Transformer and Channel ad hoc

September 2008

Fred Schindler
Cisco Systems

OCL vs V_{PSE} for Legacy Transformers

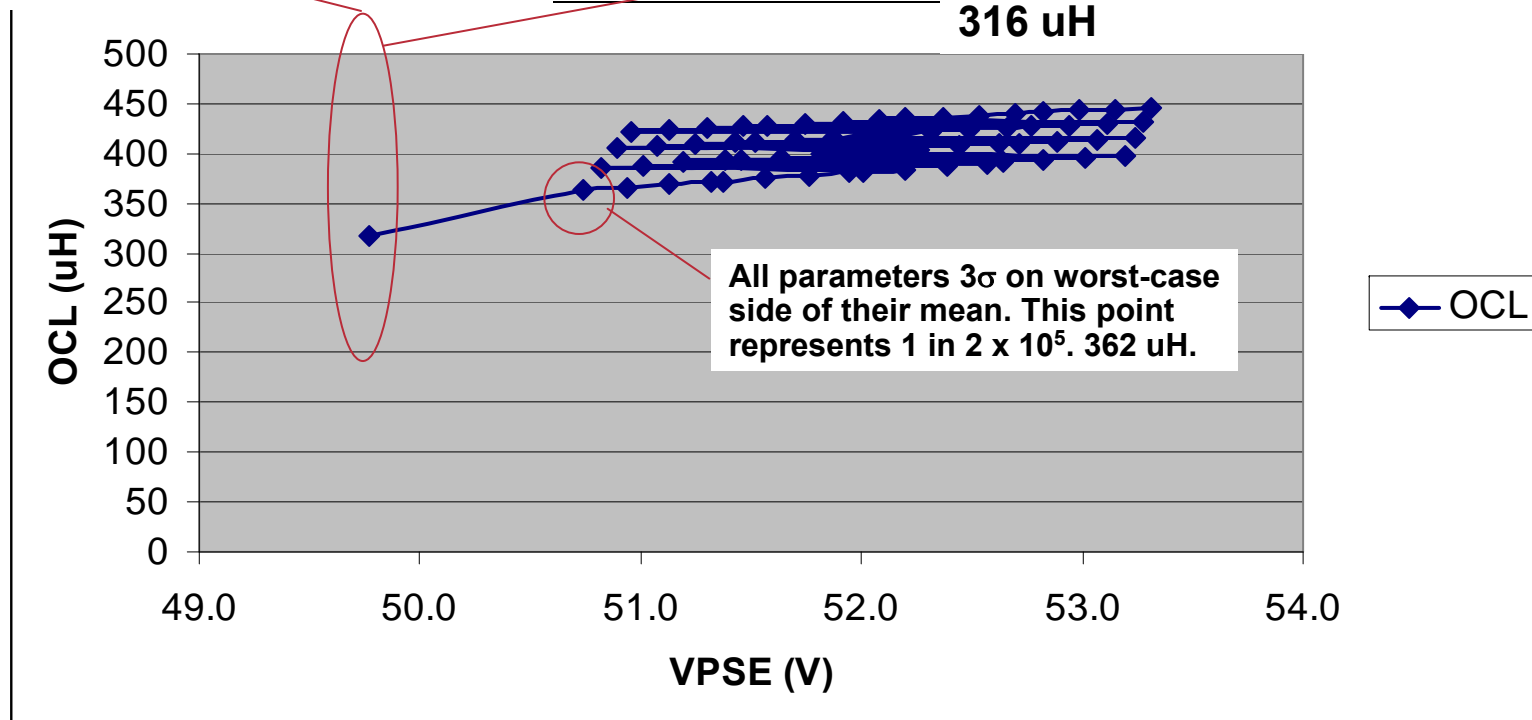
All parameters 4σ on worst-case side of their mean.

1-in-x change of being at this point. This point represents 1 in 2×10^{11} . 316 μH

V_{PSE} and R_{ch} distribution with a 28.4 W PD peak load for an IEEE 802.3at system. This encompasses a cable reach from 0 to 115 m, and assumes a **worst-case 3% channel** resistance unbalance. No allowance for BLW induced bias current. **Worst-case temperature.**

The equivalent worst-case OCL

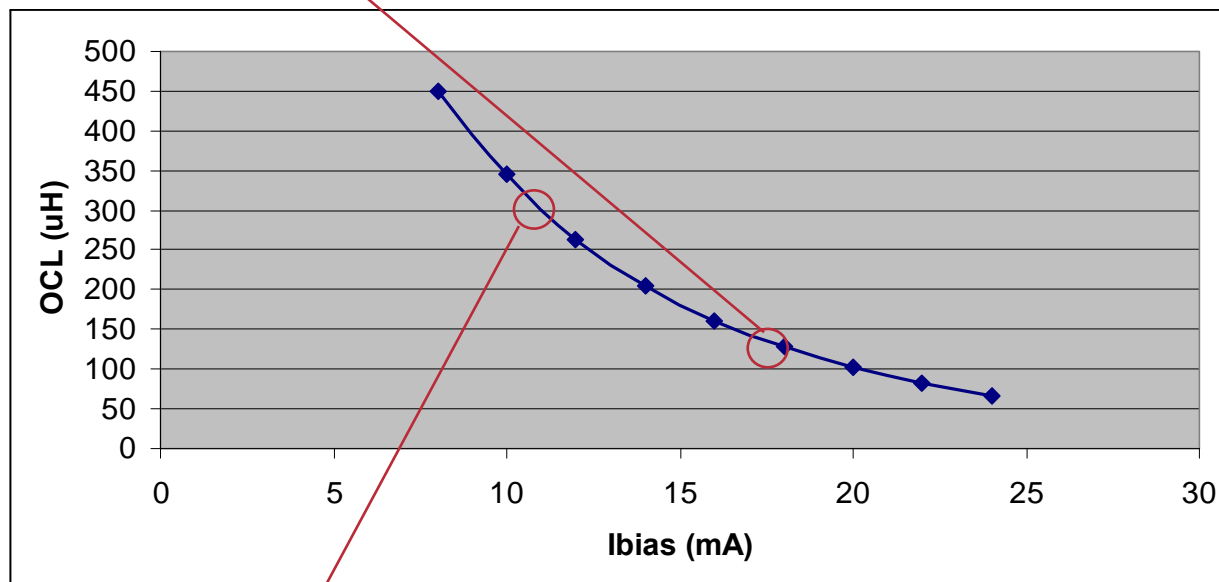
Three parameters 4σ or more on worst-case side of their mean and BLW.
 $I_{bias} = 18.8 \text{ mA}$, $OCL = 120 \text{ uH}$. $I_{bias} = I_{unbal}/2 + 8 \text{ mA}$

The OCL is 320 uH when no BLW component is present and $I_{bias} = 10.8 \text{ mA}$.
Three parameters are 4σ on the worst-case side of their mean.

This model produce 350 uH OCL at 10.2 mA bias current.

40.6.1.2.2 Maximum output droop

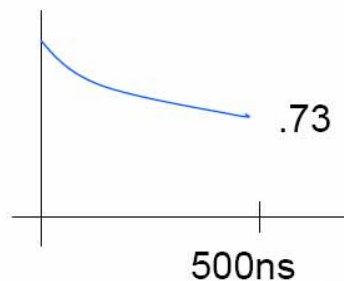
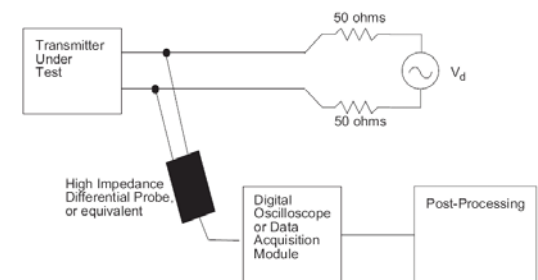
The magnitude of the negative peak value of the waveform at point G, as defined in Figure 40–19, shall be greater than 73.1% of the magnitude of the negative peak value of the waveform at point F. These measurements are to be made for each pair while in test mode 1 and observing the differential signal output at the MDI using transmit test fixture 2 with no intervening cable. Point G is defined as the point exactly 500 ns after point F. Point F is defined as the point where the waveform reaches its minimum value at the location indicated in Figure 40–19. Additionally, the magnitude of the peak value of the waveform at point J as defined in Figure 40–19 shall be greater than 73.1% of the magnitude of the peak value of the waveform at point H. Point J is defined as the point exactly 500 ns after point H. Point H is defined as the point where the waveform reaches its maximum value at the location indicated in Figure 40–19.

$$e^{-500\text{ns}/\tau} = 0.73$$

$$\tau = 1.6\mu\text{s} \rightarrow \underline{\text{OCL} = 80\mu\text{H}}$$

Gigabit already designed
to tolerate low OCL

Open Issues

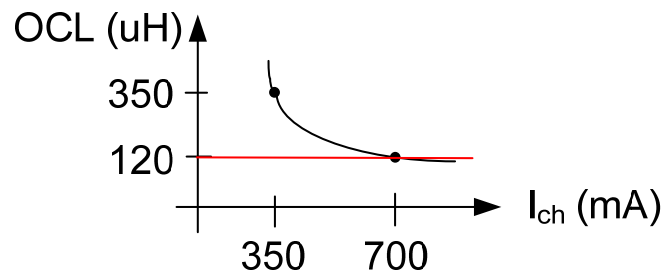
- Correct typo lunbal should be lunb.
- Should we require $lunb = 3\% \times I_{peak}$ for a type 2 system?
AdHoc YES

Use the highest peak value.

$3\% \times 600 \times 400/350 = 20.6 \text{ mA}$

Therefore, $lunb/2 = 20.6/2 = 10.3 \text{ mA}$.

At 10.3 mA, OCL = 320 uH.

At $10.3 + 8 = 18.3 \text{ mA}$, OCL = 120 uH

Instruct the Editor to Modify Table 33-11, item 21, PSE type field, reference 33.2.9.13.

Add new line item 21, Max field “3% x Ipeak”, PSE type field, Type 2. Remove Type 2 from the preexisting item 21.

Open Issues Continued

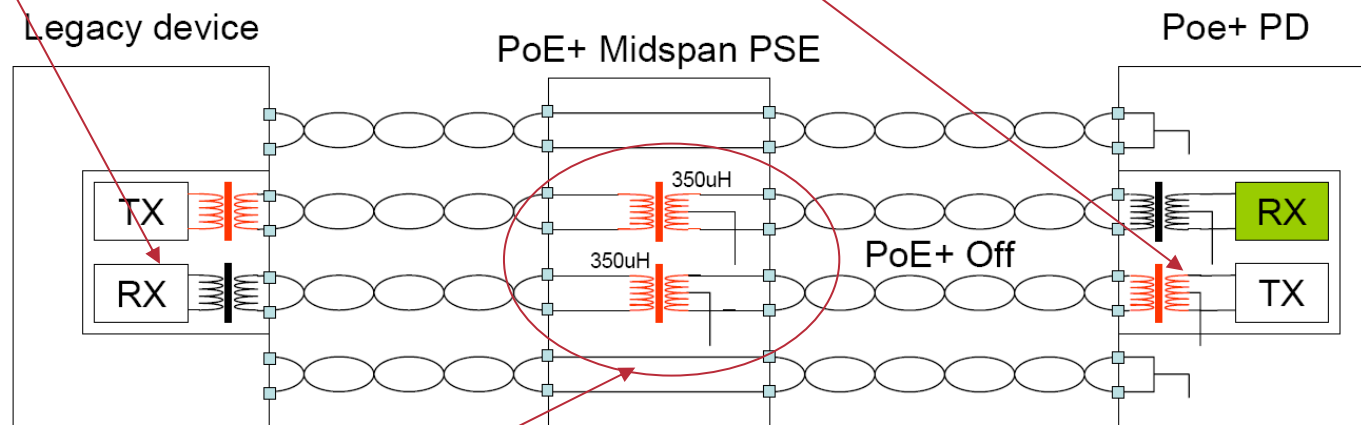
- **How to enable low cost PDs?**

A PHY in a system **consisting of a Type 2 Endpoint PSE and a Type 2 PD, delivering more than 12.95 W average power**, shall meet the Open Circuit Inductance (OCL) requirement in 9.1.7 of TP-PMD or have an equivalent system time constant that **exceeds 2.4 μ s ~~(for the PSE) or 7.0 μ s (for the PD)~~** when transmitting the Data Dependent Jitter (DDJ) packet of TP-PMD A.2.

More PD ports are expected to ship than midspan ports. Requiring PDs to add cost to support midspans is the incorrect tradeoff.

How to enable low cost PDs?

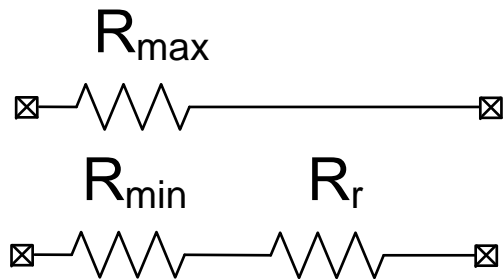
e) Create a rebalancer cable that reduces a 3% channel resistance unbalance to 1.75%. Then neither the midspan or PD need to do anything extra.

If this solution is required, the Editor should insert the following text in the appropriate place:

Modify Table 33-11, item 21, PSE type field, reference 33.2.9.13.

Add new line item 21, Max field 1.75%, PSE type field, reference 33.2.9.13.

Add text to 33.2.9.13 after the last line: “Type 2 endpoint PSEs, Type 2 midspan PSE that are not supply power on signal pairs of a 100BASE-TX system and Type 2 PDs shall operate using the larger unbalance specified in Table 33-11, item 21. Type 2 midspans that provide power on the data pairs of a 100BASE-TX system shall operate using the smallest unbalance specified in Table 33-11, item 21. A rebalancer cable may be used in place of a patch-cord/jumper-cable, see Figure 33-26, to adjust the channel unbalance resistance to less than or equal to the smallest unbalance specified in Table 33-11, item 21.”

Proposed Solution to Enable Low Cost PDs

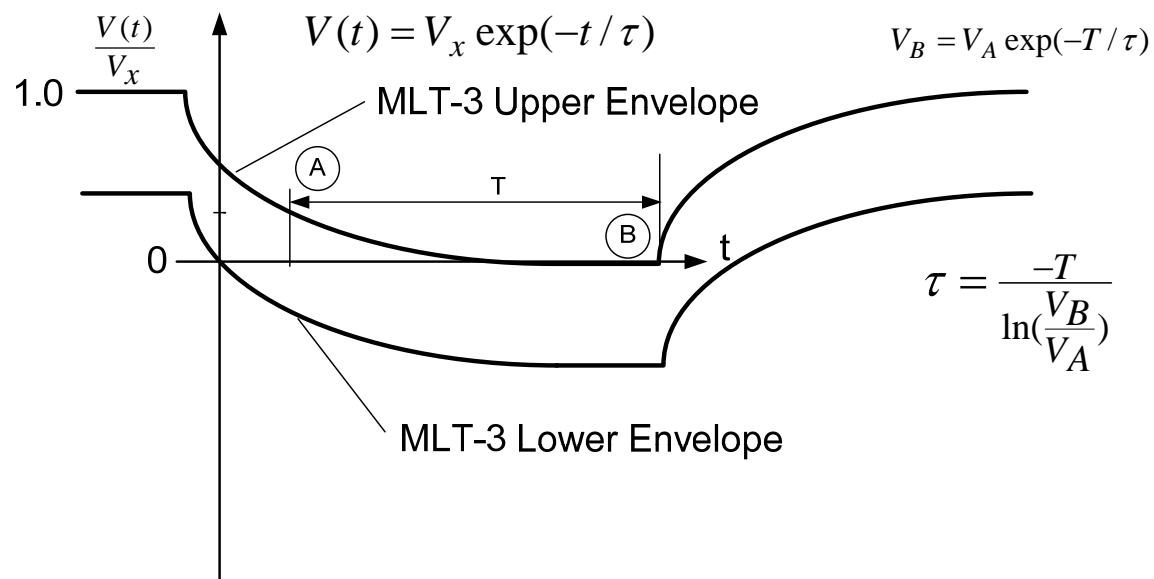
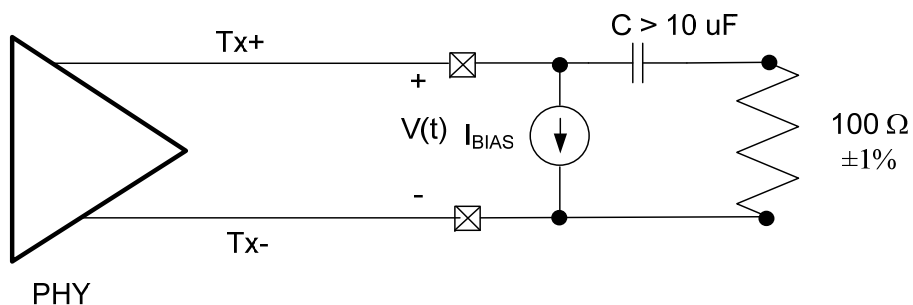
100BASE-TX systems may contain a legacy PHY receiver that expects to be connected to PHY transmitter with 350 uH open circuit inductance (OCL). Alt-A Type 2 midspans that support 100BASE-TX shall ensure channel unbalance currents less than or equal to **Type 1 I_{unb} , see Table 33-11, item 21.**

See comment #112

Add, additional information pointer to this from Table 33-11, item 21.
